## Marine Safety Center Vapor Control System (VCS) Plan Review Information Sheet (PRIS)

Vessel Name	CBC 90	Shipyard	Jeffboat
Official Number	1141494	Hull Number	03-2972 & 03-2977

VCS Approval Letter C1-0304452 dated 25Mar03      MSC Plan Reviewer LTjg Hsing-Yen Fu

### LIQUID TRANSFER RATE VS FACILITY VAPOR CONNECTION PRESSURE

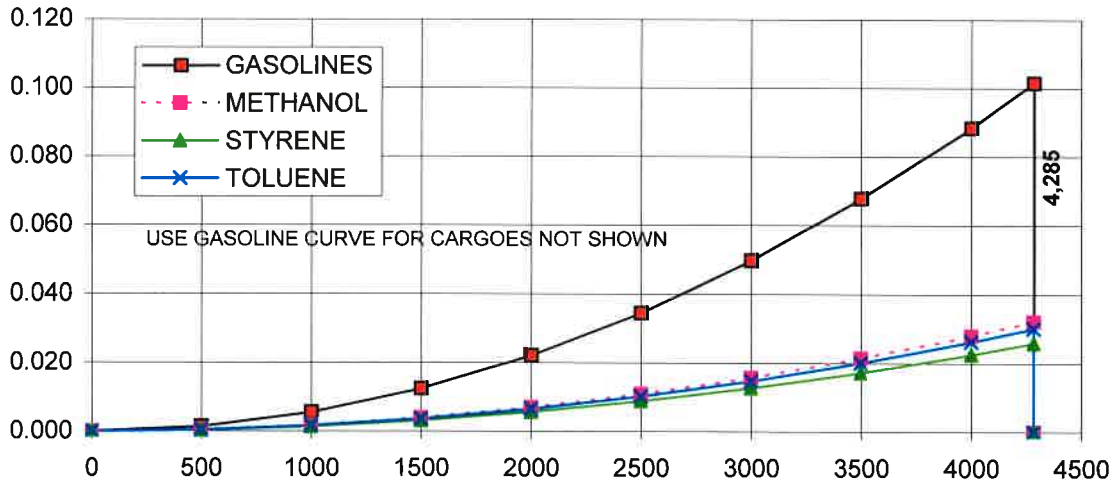
9c. Verify isolation valve at the vapor connection flange is manually operable and designed in a way it is "clearly" open or closed.
